Item ID: D407-667-205TRN

Item Name: Crosstube Turning Detail

<b>DART AEROSPACE LTD</b>		<b>Work Order:</b>	<b>115333</b>
<b>Description:</b> Crosstube Assembly		<b>Part Number:</b>	<b>D407-667-245</b>
<b>Inspection Dwg:</b> D407-667-245 <b>Rev:</b> F		<b>Page 1 of 2</b>

DRAWING NO. D407-667-245	TITLE CROSSTUBE ASSY (407 HIGH AFT)	REV. F	DART AEROSPACE LTD ENGINEERING ORDER		D.E.O. NO. D407-667-245-F-1	SHEET NO. SHEET 1 OF 2	SCALE NTS
DRAWN	CHECKED	MFG. APPR.	APPROVED	DE APPR.			
DATE 11.04.08	DATE 11.04.12	DATE 11.04.12	DATE 11.04.12	DATE 11.04.12	DATE 11.04.12

**D407-667-245 MACHINING DETAIL**

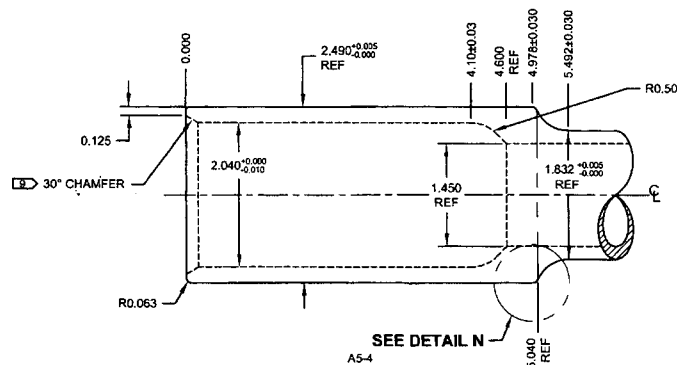
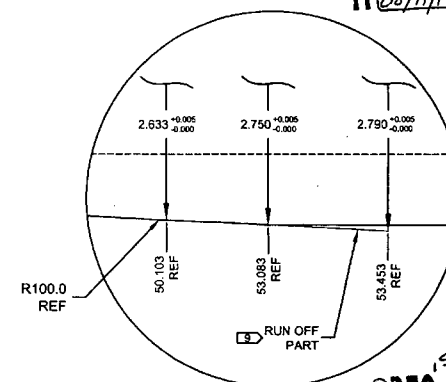
Root Cause	Date	Step	Qty	Description of work order update or non-conformance	Initial Chief Eng	Action Description	Sign & Date	Verification	QC Inspector
Design				Cuff dim is 2.451" and should be 2.420"	DAS 16 9-89	SCRAP UP 14/3/31			DAS 16 9-89
Doc/Data									
Equip/Tooling									
Handling/Pre									
Material									
Operator									
Offset/Setup									
Process									
Supplier									
Training									
Transport									
Unapproved

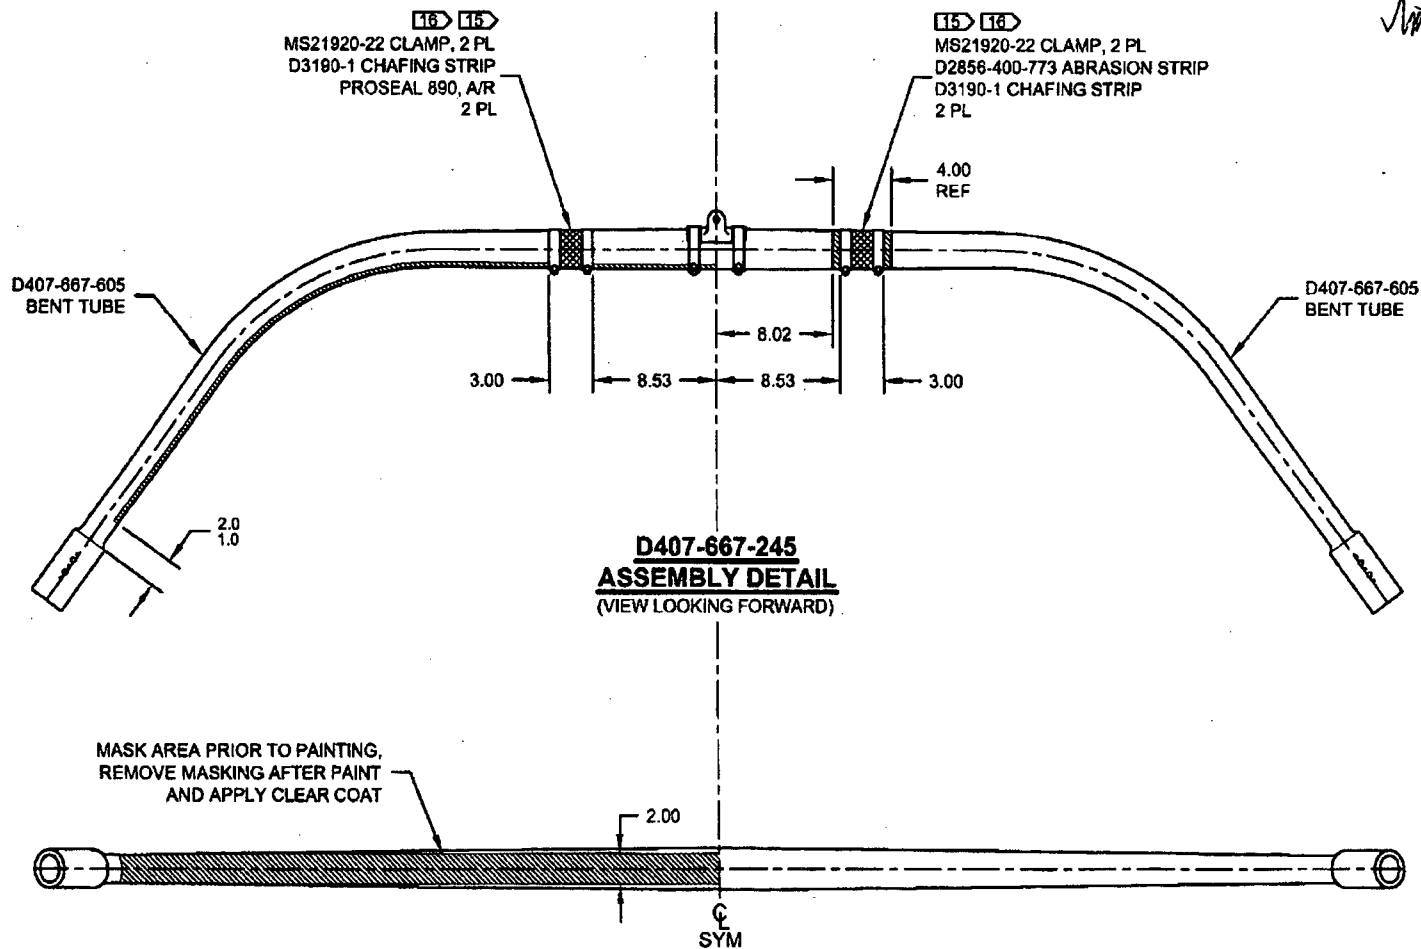
**PURPOSE:**

REMOVED ABRASION STRIP IN FAVOR OF A THIN LAYER OF PROSEAL 890.

NOTES 2 AND 15, SHEET 1 ARE AMENDED AS FOLLOWS:

- 2) FINISH: CHEMICAL CONVERSION COAT PER DART QSI 005 4.1  
PRIME INSIDE AND OUTSIDE PER DART QSI 005 4.2  
MASK UNDERSIDE OF CROSSTUBE AS SHOWN (HATCHED AREA) AND  
PAINT OUTSIDE PER DART QSI 005 4.2  
REMOVE MASKING AND APPLY CLEAR COAT
- 15) APPLY A THIN COAT OF PROSEAL 890 ON INSIDE CONCAVE SURFACE OF D3190-1  
CHAFING SHIELDS AND LET CURE PER MANUFACTURER'S INSTRUCTIONS. INSTALL  
PROSEALED D3190-1 CHAFING SHIELDS ONTO CROSSTUBE BY APPLYING A THIN COAT  
OF PROSEAL 890 ONTO CROSSTUBE. BE SURE TO ELIMINATE ANY AIR GAPS.
